MEMORANDUM

DATE: November 26, 2013

SUBJECT: BZA Case 18655 – Application of Bank of America, pursuant to 11 DCMR §§§ 3104 1, 1304 1 and 1325, for a special exception to exceed the 20 percent limit on the amount of the ground floor that may be devoted to banks under subsection 1302 4(a) in order to install an automatic teller machine (ATM) banking center in the HS-R/C-2-A District at premises 1102 H Street, N.E (Square 981, Lot 806)

SPACE ANALYSIS (A00.00 – Submitted Plan)

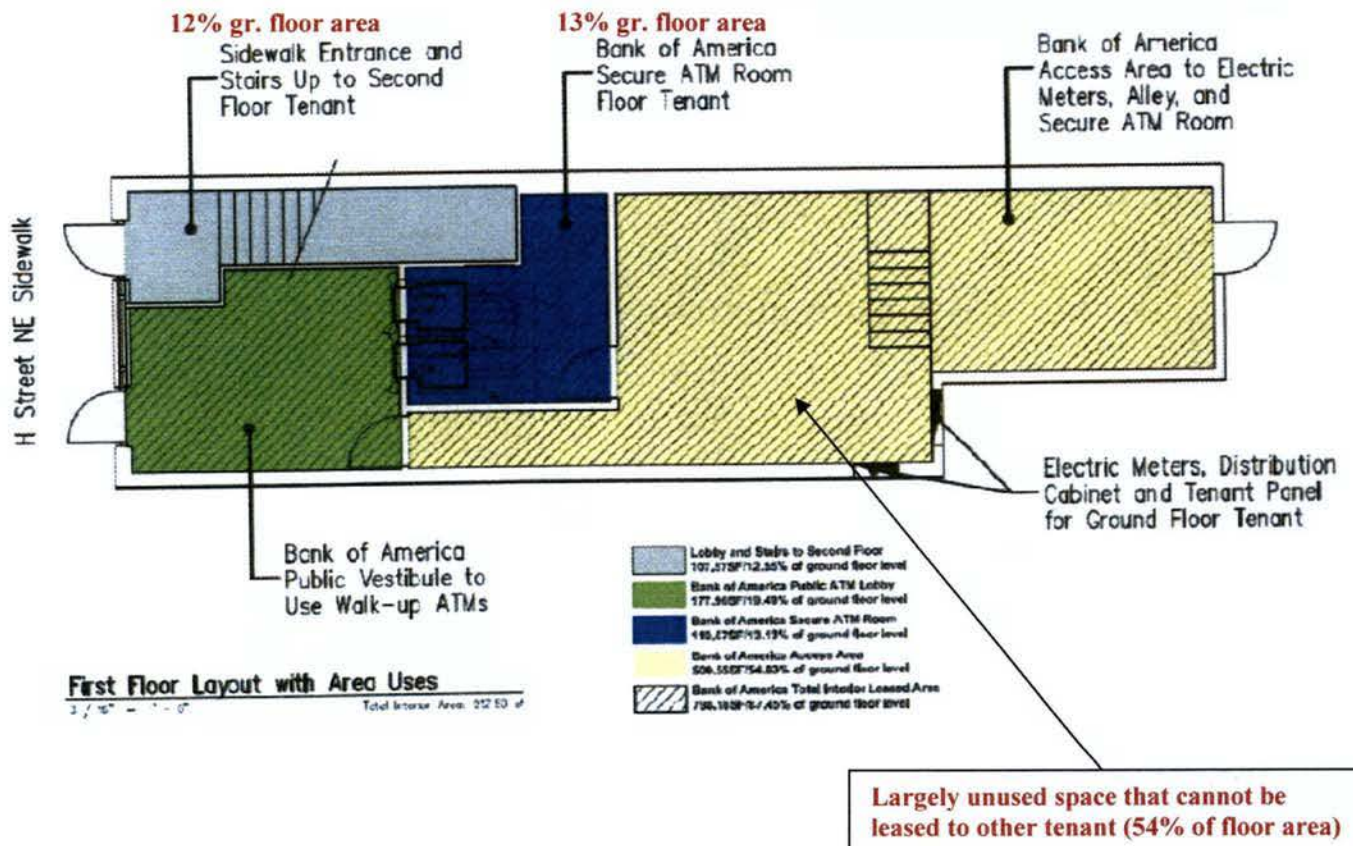
The applicant, Bank of America has proposed the use of the entire area of the ground floor of the commercial row structure at 1102 H St., NE for the installation of its bank ATM. The existing 1,330 square-foot lot is developed with a row structure at 68% lot occupancy with no legal alley access at its rear. The proposed customer lobby would be just under 20% of the first floor area and would be the only public area on the floor to provide customer access to the walk-up ATM's. The ATMs would be installed in a secure area behind the customer lobby, with accessory electronic equipment and electrical cabinets required for the ATMs to function. The facility will be unmanned with infrequent visits by technicians to service the ATMs and its related equipment. This secure area represents about 13% of the ground floor space. (No plumbing would be installed at this level.)
